## **Statement of Response to LRD Opinion**

**Lands at Glencarrig House,  
Simmonstown,  
Celbridge,  
Co. Kildare,  
W23Y9PY**

**On behalf of  
Garyaron Homes Ltd.**

August 2022

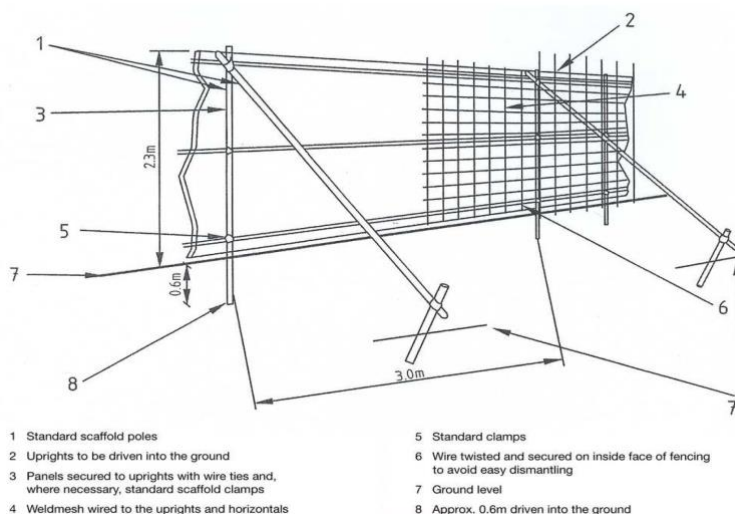
*A Construction management Plan to include Tree protection measures during construction works on the site. Any tree protection strategy should be informed by the Arboricultural Assessment Report*

This LRD application includes a Construction Management Plan which has been prepared by Garyaron Homes.

The Construction Management Plan also has regard and refers to the construction mitigation measures outlined in the Ecological Impact Report by Malachy Walsh and

Partners and to the Tree Protection Measures outlined in the tree protection plan by Arborist Associates.

Proposed Site Layout and Junction Layout

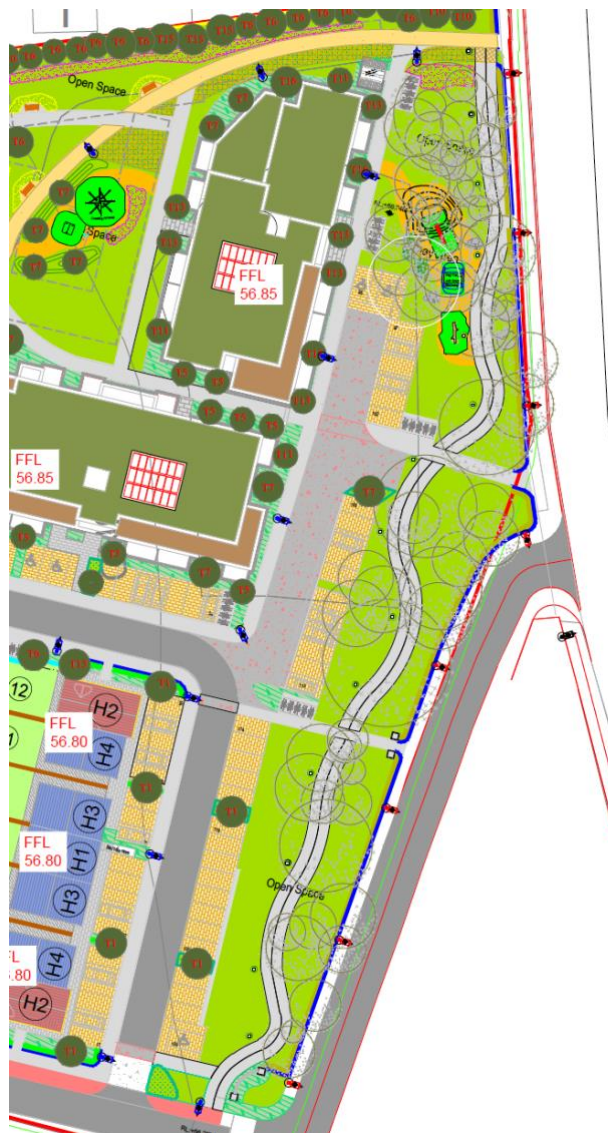
- a) The prospective applicant is requested to examine the junction between the L5062 and the R405 with a view to improvements with VRU facilities, gradients and sight lines.

The above details provide significant improvements to the layout of the junction between routes L5062 and R405 to include enhanced facilities pedestrians, cyclists and vehicles. We trust this is to the satisfaction of the Planning Authority.

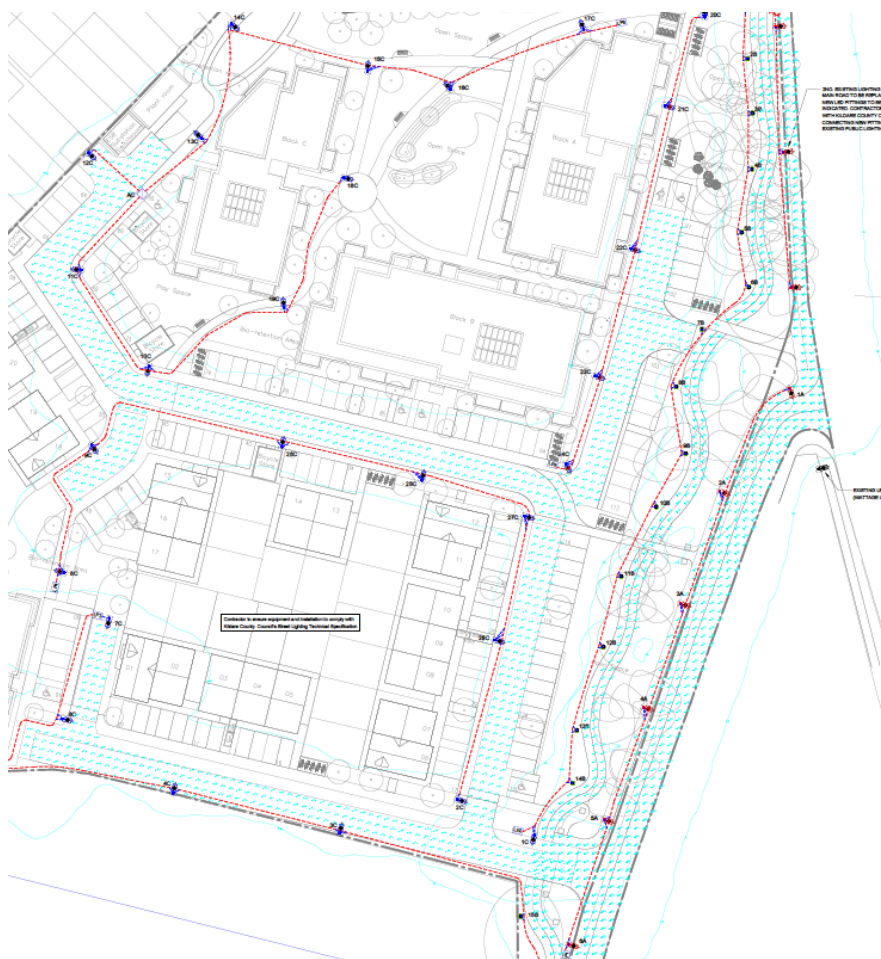
*The proposed shared facility for vulnerable road users through the parkland area should be a minimum of 3m wide with public lighting in place to ensure proper passive surveillance, safe facilities at night time and adequate room for vrus travel on.*

The proposed path will be lit by low level bollard lighting to allow for minimal impact on the existing trees and to provide adequate lighting for safety along the proposed path. We trust this is satisfactory to the Planning Authority.
